Access Compliance Report

Public Rights-of-Way

(Pedestrian Signals)

Intersection ID: N/A	Main Street:	Cross Street: N/A	Location: N/A
ADA ID: 9D778733DD7C	Signal Type: Two Push Buttons-APS	Overall Compliance: No	Severity Score: BTN 1:N/A BTN 2: N/A No BTN: N/A
Codes/Mitigation Info/Possible Solution		Field Measurements/Component Compliance

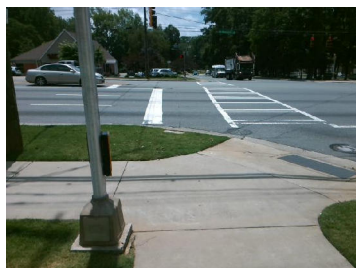
Surveyor Notes: TEXT HT 3/8

PROW/ADA: R410.6, TMUTCD 4e.08, R404.2, R404.3, R406.2, R104.2, R209.1,

Possible Solutions: Replace Signal Push Button With APS Button on New Post. Remove & Replace Sign.
